PART 21 REPORT INVOLVING TYPE 546NS TRANSDUCERS

"Fisher Information Notice: FIN 2013-01; 9 January 2013

"Subject: Type 546NS Transducers

Figure 1

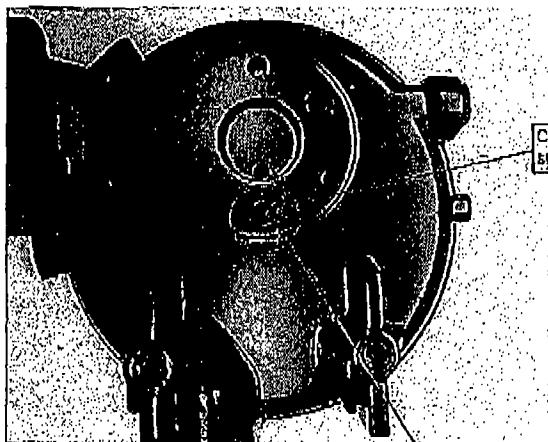
This procedure is to be used to inspect the 546 transducer vent passage between the 546 case and 82 relay for a possible obstruction due to aluminum flash in the vent passage. If the vent passage is found to be obstructed by aluminum flash, the flash may be removed with a punch or other hard pointed object by breaking and removing the flash. The 546 transducer will operate normally once the flash is removed and the relay is re-installed.

1. To remove the type 82 relay, perform step 1. of the Relay Removal and Replacement instructions on page 15 of the instruction manual.
2. Inspect the case vent passage (see figures 1 - 3). The passage should be open and the interior surface of the flash suppressor should be visible through the hole (see figures 1 and 2). If the passage is obstructed with aluminum flash, the passage will appear to be a blind hole (see figure 3).
3. If the passage is obstructed with aluminum flash, use a punch or other hard sharp instrument to break the flash and remove it from the vent passage.
4. Once the aluminum flash is removed, or if no aluminum flash is present, re-install the type 82 relay by performing step 3 of the Relay Removal and Replacement procedure on page 15 of the instruction manual.
5. The 546 transducer is now ready to be placed into service.
